CITY OF MOLALLA WASTEWATER TREATMENT PLANT UPGRADES VALUE ENGINEERING REPORT DECEMBER 10TH, 2021

UPDATED FEBRUARY 11, 2022
WITH IMPLEMENTATION DATA

This value engineering (VE) report is presented to City of Molalla and the design team to support decision making at the pre-design phase for the Wastewater Treatment Plant Upgrades project.

PROPOSAL	P-1
COMPONENT: Plant Location - West	AUTHOR	NLC
CURRENT CONCEPT		
Construct the SBR in the northwest corner of Lagoon No. 2.		
VE CONCEPT		
Acquire adjacent property and construct SBR to the west.

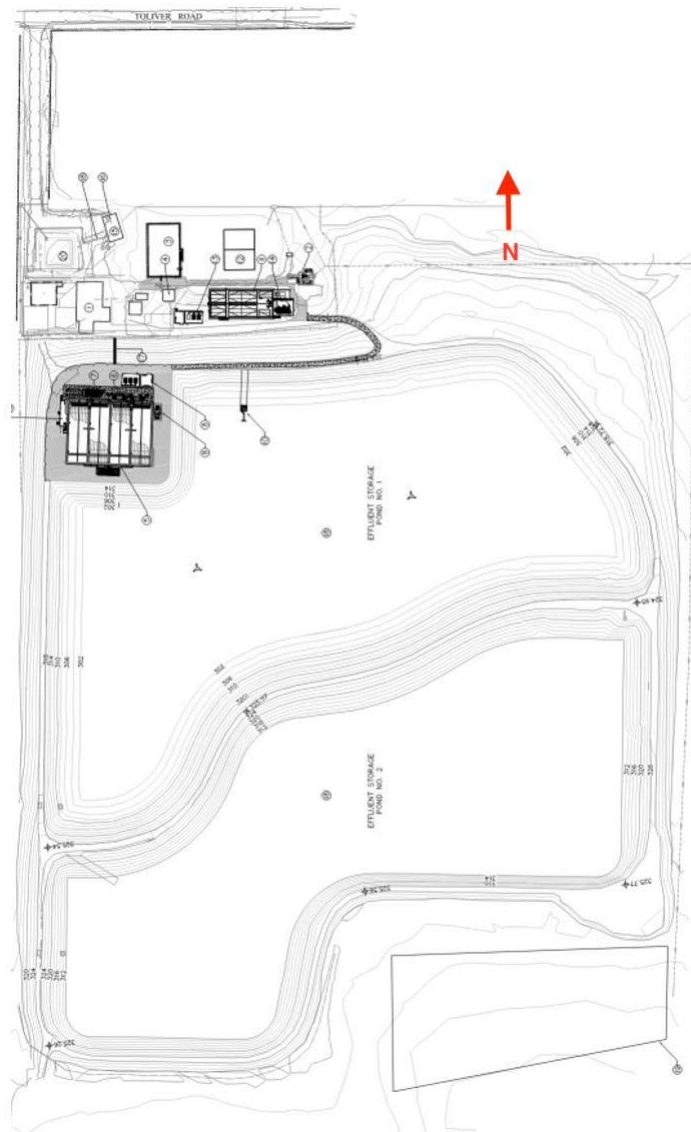
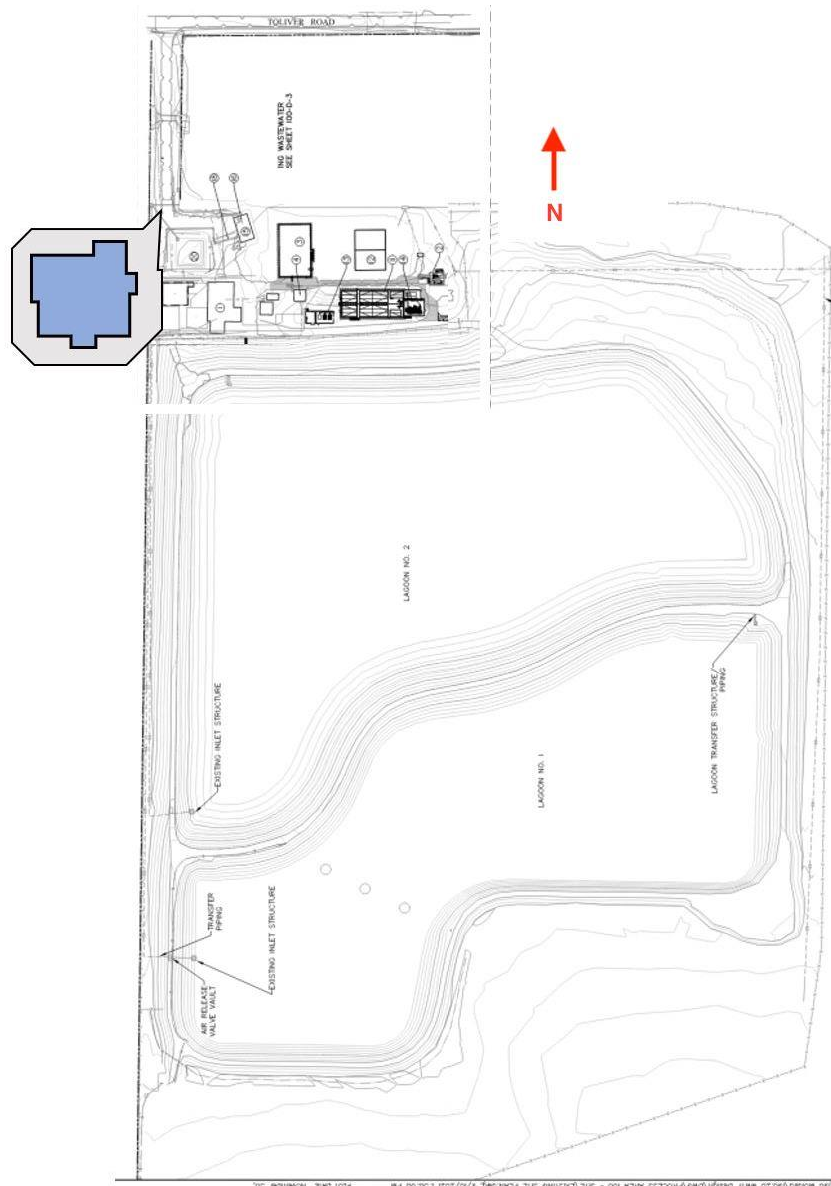
Constructing the SBR within the existing lagoon requires construction and removal of a temporary cofferdam/liner system and additional earthwork at a cost of approximately \$2 million. Acquisition of a portion of the adjacent property to the west will reduce first cost of the SBR by eliminating the temporary cofferdam.

Placement of the SBR in the lagoon location does not solve existing plant process and vehicular circulation inefficiencies. Acquisition of the entire adjacent western parcel opens up many opportunities for life cycle cost savings including consolidation of plant systems and processes and improved vehicular circulation. In addition, it allows for future expansion and provides a large area for water storage/irrigation.

The disadvantages of this option are tied to the delays and costs associated with land acquisition.

P-3	Plant Location - East	1,027,000		X			The northeast area of the WWTP is less favorable than the area the City is pursuing to the west. The construction of new treatment process facilities in the northeast area of the WWTP site will require additional geotechnical considerations, wetland mitigation, existing sewer line re-alignment, and an effluent pump station.
P-4	Scope & Capacity	5,975,000		X			To meet current design parameters, provide operational flexibility, and accommodate future growth, it is recommended that the system components be constructed per the current design and not reduced in size. Reducing the capacity of the transfer pump station and SBR, for example, would not provide capacity for existing conditions (flows and loads).
H-1	Hydraulic Gradient	371,000		X			This proposed alternative would require increasing the transfer pump station and grit removal system capacity from 8.8 mgd to 12.07 mgd, a 37 percent increase in size. Diurnal flow equalization, as recommended, would also require re-pumping of equalized flows from the transfer pump station to the SBR, thereby increasing life-cycle costs.

PROPOSAL	P-2
COMPONENT: Plant Consolidation	AUTHOR	NLC
CURRENT CONCEPT		
Construct the SBR in the northwest corner of Lagoon No. 2.		
VE CONCEPT		
Demolish existing plant Office/Treatment Building and construct SBR in its place. Provide new office and lab.

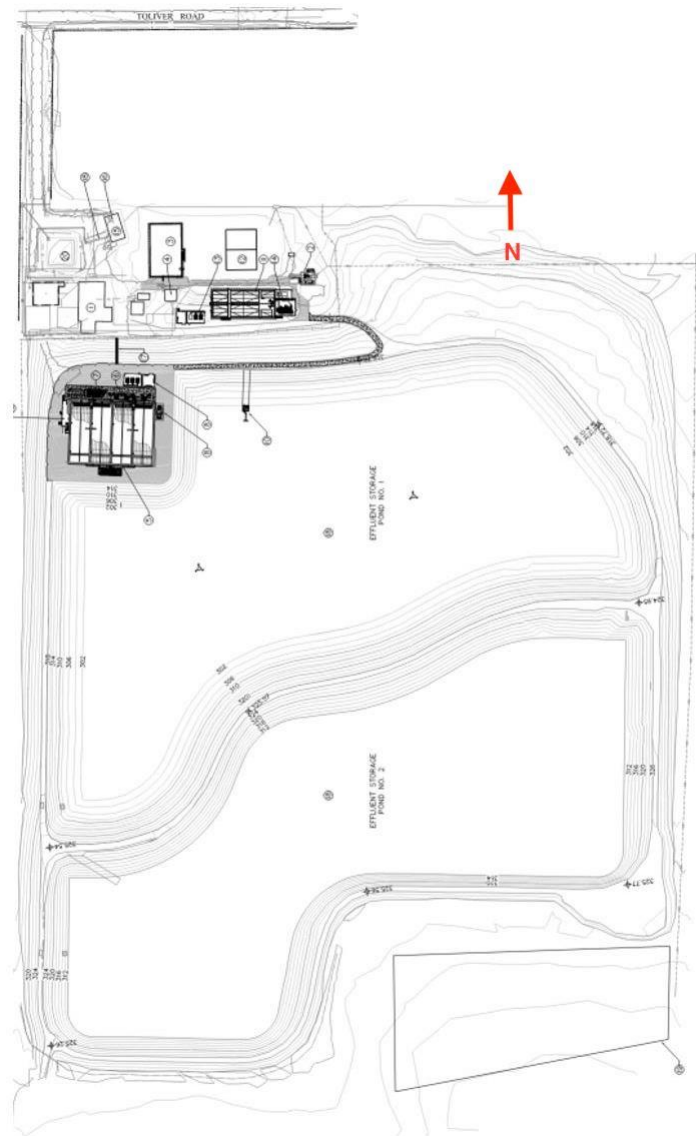
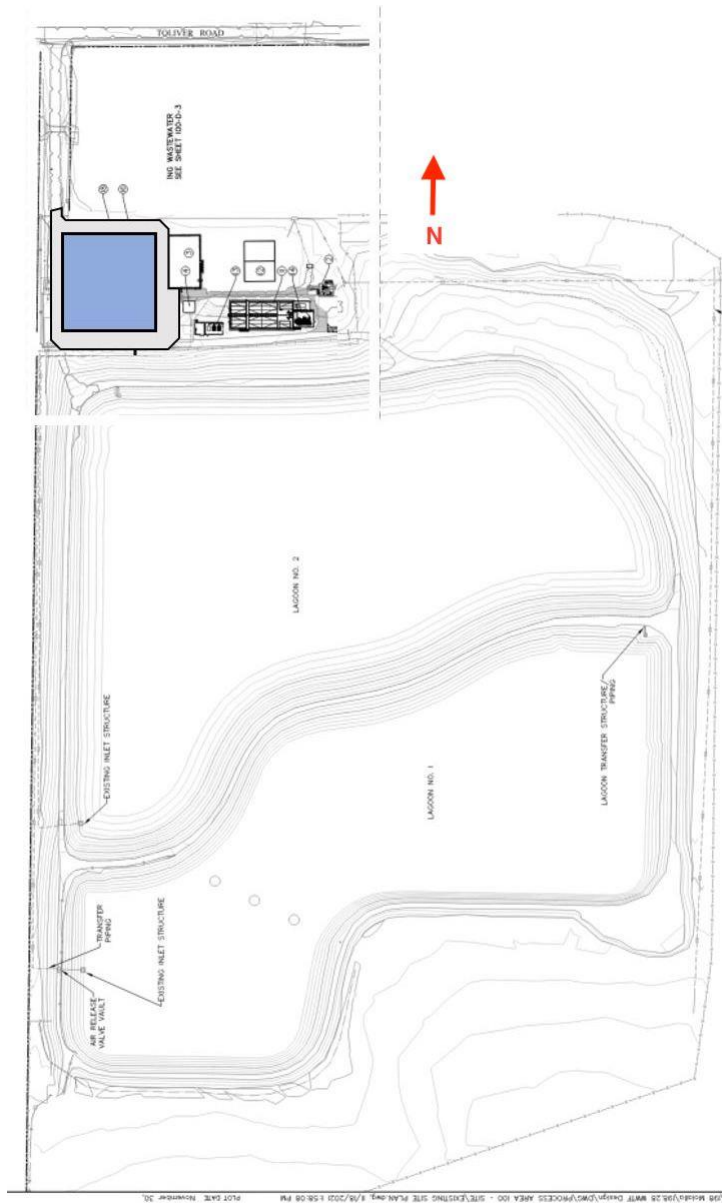
<p>DISCUSSION</p> <p>Constructing the SBR within the existing lagoon requires construction and removal of a temporary cofferdam/liner system and additional earthwork at a cost of approximately \$2 million. Demolition of the existing plant Office/Treatment Building and construction of the SBR in its place will reduce first cost by eliminating the temporary cofferdam.</p>

PROPOSAL	P-2
COMPONENT: Plant Consolidation	AUTHOR	NLC
<p>Placement of the SBR in the lagoon location does not solve existing plant process and vehicular circulation inefficiencies. Construction of the SBR in the existing plant Office/Treatment Building location allows for consolidation of plant footprint and piping, which will optimize plant systems and processes while maintaining the existing lagoon size. This location allows for improved plant hydraulics.</p> <p>Disadvantages of this option are that it requires more complex construction phasing and additional building demolition. It also requires a temporary solution for the existing administration and laboratory functions.</p>

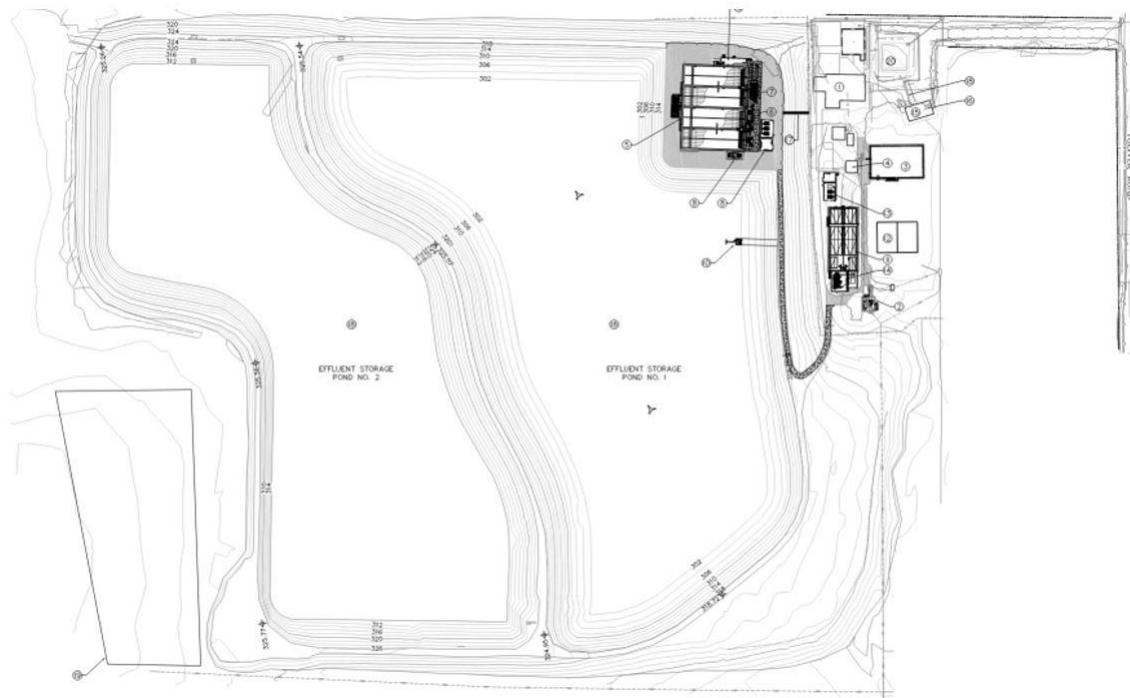
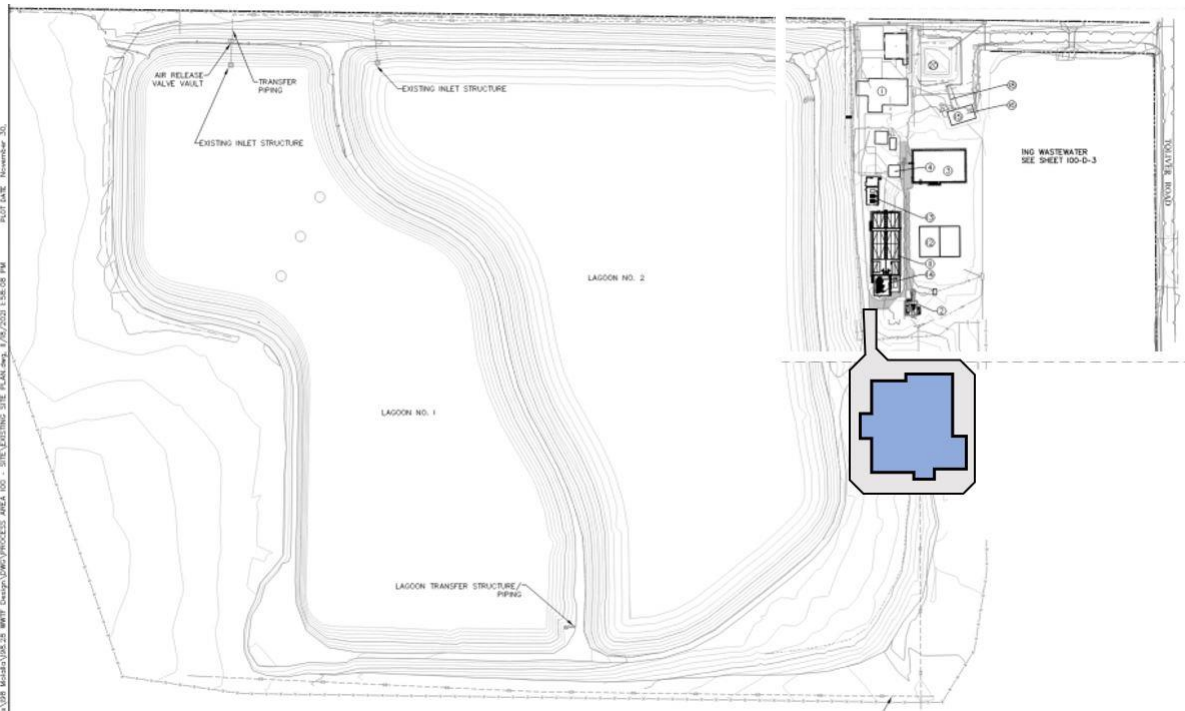
<p>DISCUSSION</p> <p>The current SBR location is in the northeast corner of existing pond No. 1. The corner of the pond would be sealed off with a temporary cofferdam, drained, and cleaned to expose native soils. Imported structural fill would be placed to fill the corner of the pond up to the same grade at the pond berm tops. The cofferdam would be removed to expose the new lined pond berm slope. The SBR would be constructed on the new structural fill pad.</p>
--

The SBR would be relocated to the land east of the plant. The location is in-line with the plant outflow, streamlining the treatment process. The current grade is underlain by loose/soft fills derived from the excavation of Ponds 1 and 2. The old fills are up to 20 deep. The fills deepen the farther east you move away from the plant. The old fills are settlement prone. If the old fills cannot be economically removed and replaced below the SBR, the SBR can be supported on stone columns or drilled foundation piles to mitigate the settlement risk. Depending on the design grade of the SBR, new fills may be required to raise existing grades above the old fills east of the plant. Stone columns or drilled foundation piles are still required to support the SBR if new fills are placed above old fills to raise site grades.

PROPOSAL	P-4
COMPONENT: Scope & Capacity	AUTHOR	DCS

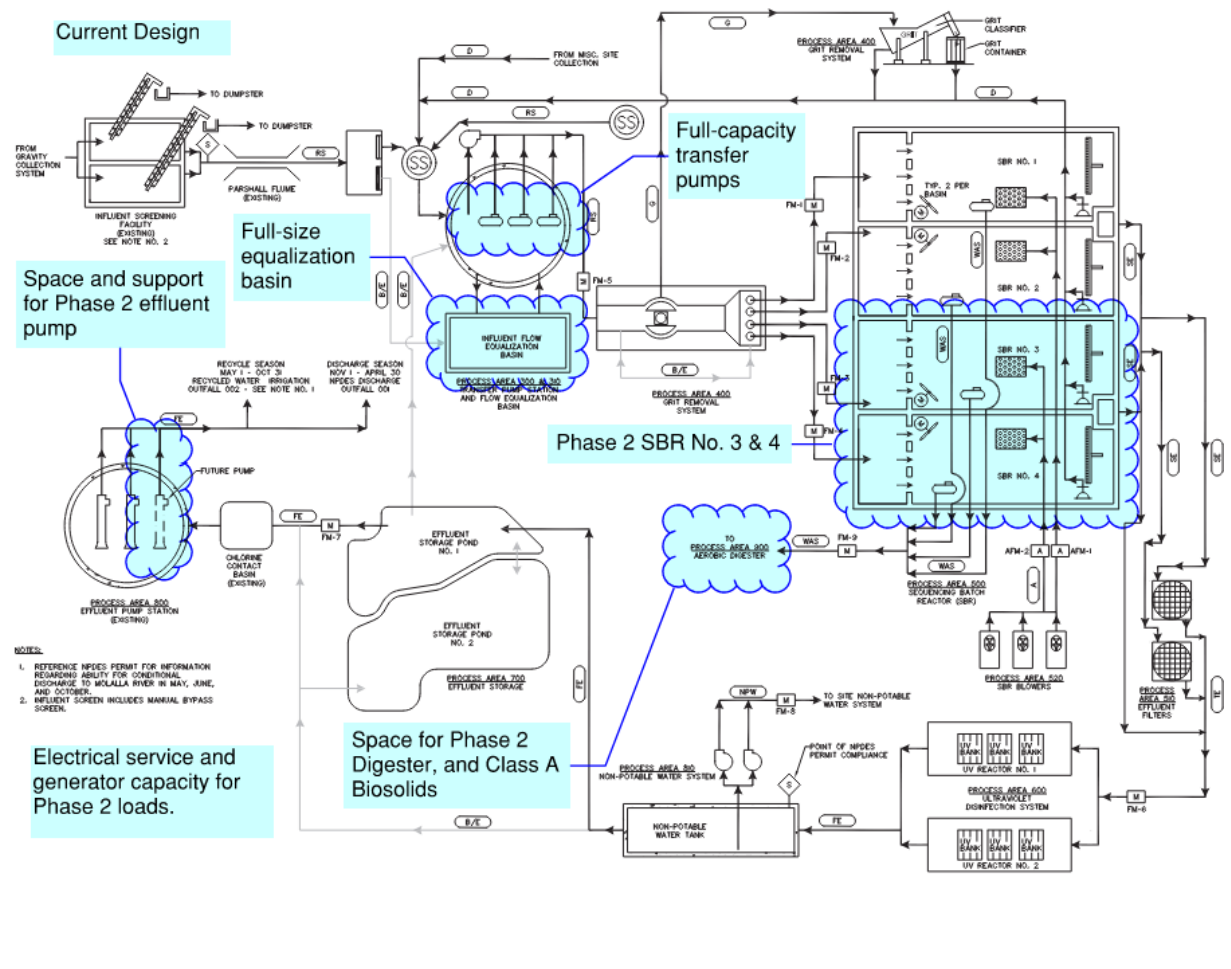
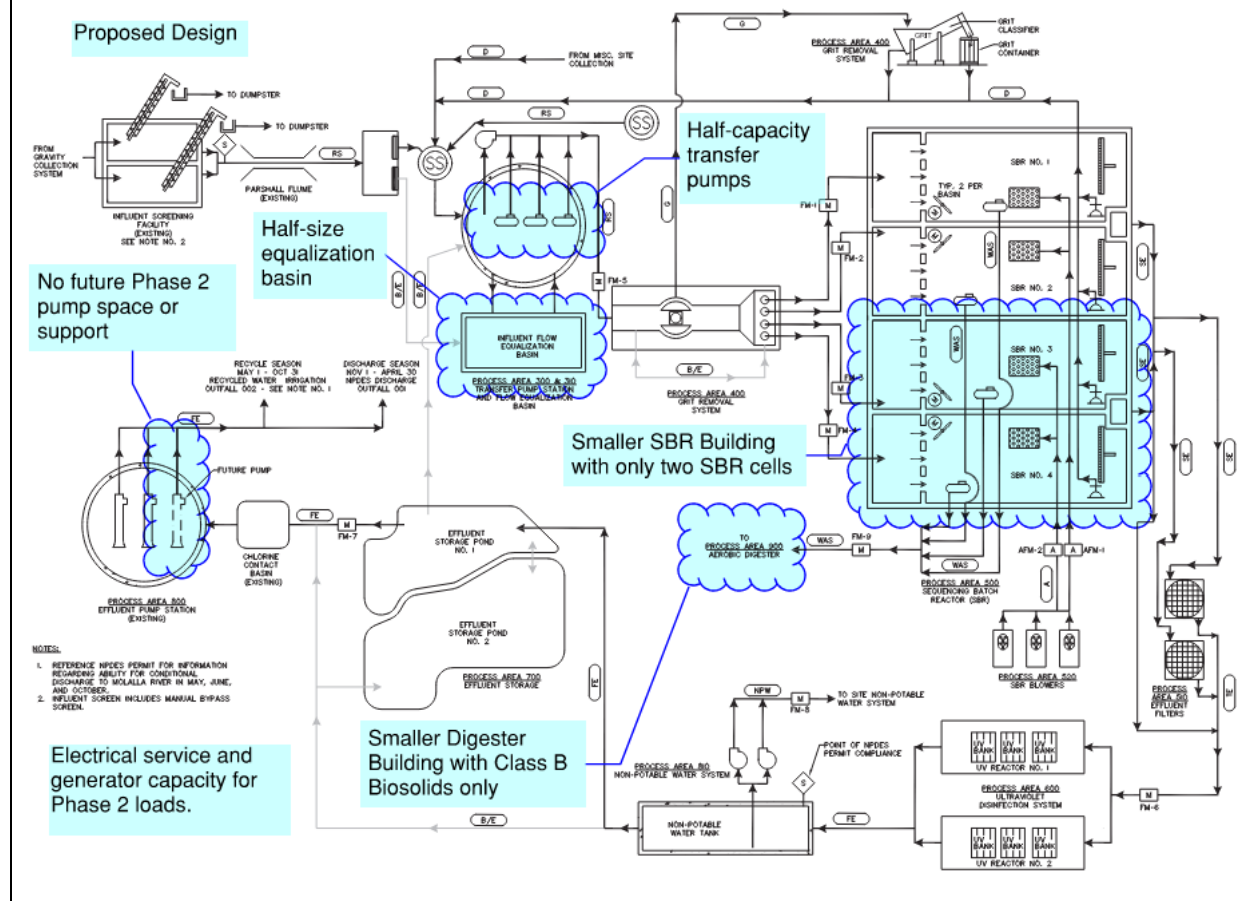
The current design assumes the City will grow per 30-year projection, which is subject to change; actual growth could be significantly more or less than projected, changing the design criteria for Phase 2 of the project.

Waste stream characteristics, regulatory environment, climate, I&I reduction, and especially technology may change before Phase 2.

This proposal suggests following LEAN principals to only design and build for Phase 1, with only minimal provisions for Phase 2.

PROPOSAL	H-1
COMPONENT: Hydraulic Gradient	AUTHOR	EF

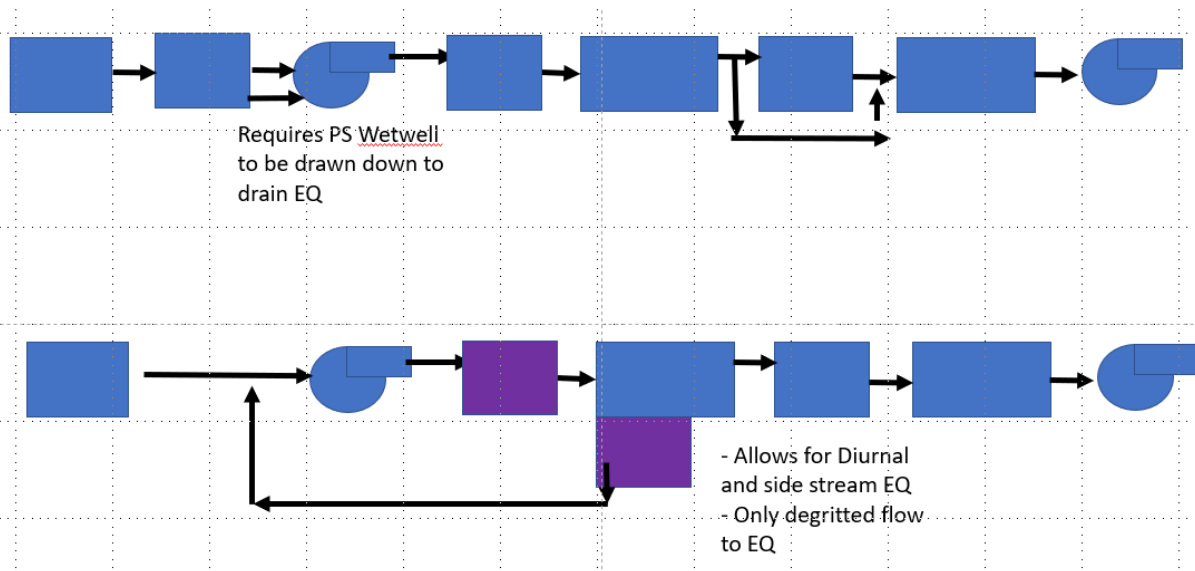
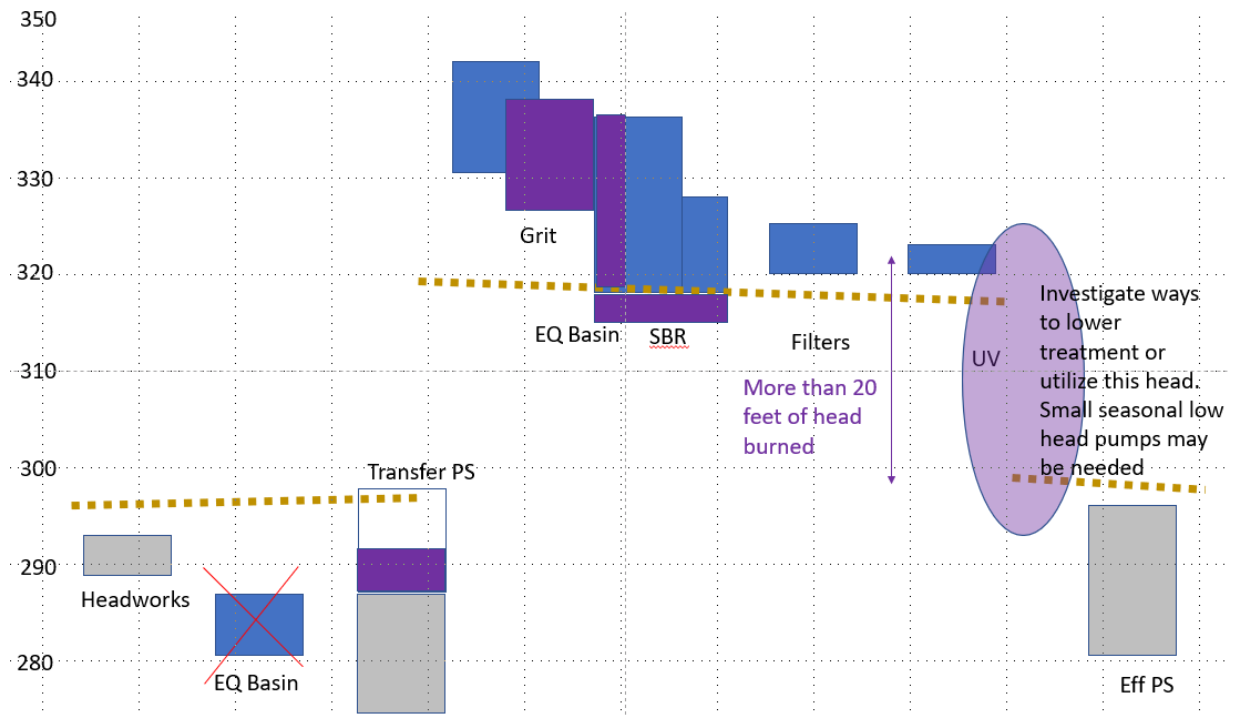
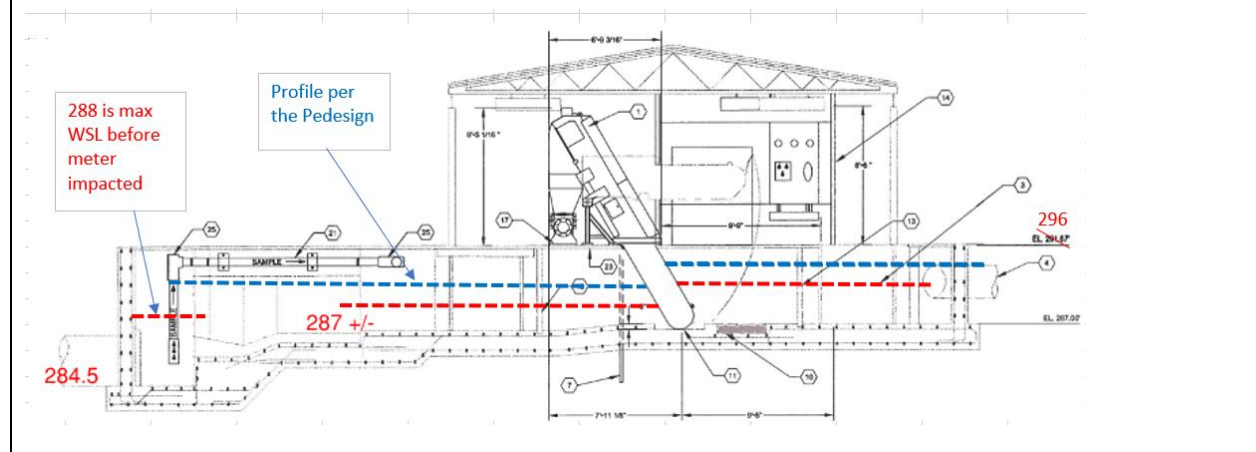
<p>DISCUSSION</p> <p>The existing plant profile is set by the headworks and the effluent pump station. Proposed equalization is the lowest point in the plant. When equalization is used, the transfer pump station wet well must be brought to a very low level to empty the tank. The profile also shows as much as 30 feet of head being wasted across the site from the headworks to the effluent including a 20-foot drop between the UV and the effluent pumps. Some of that head is used to get into the lagoons. However, when the lagoons are removed from the main process stream, the plant profile can be lowered and</p>
--

optimized. Additional pumping is needed to use the lagoons but that increase in energy use is offset by:

- Raising the transfer pump station wet well operating level
- Using the Headcell effluent weir as an active component in the EQ and distribution to the SBRs
- Recovering head burned on the effluent end of the SBRs
- Allowing the headworks flume not to be flooded
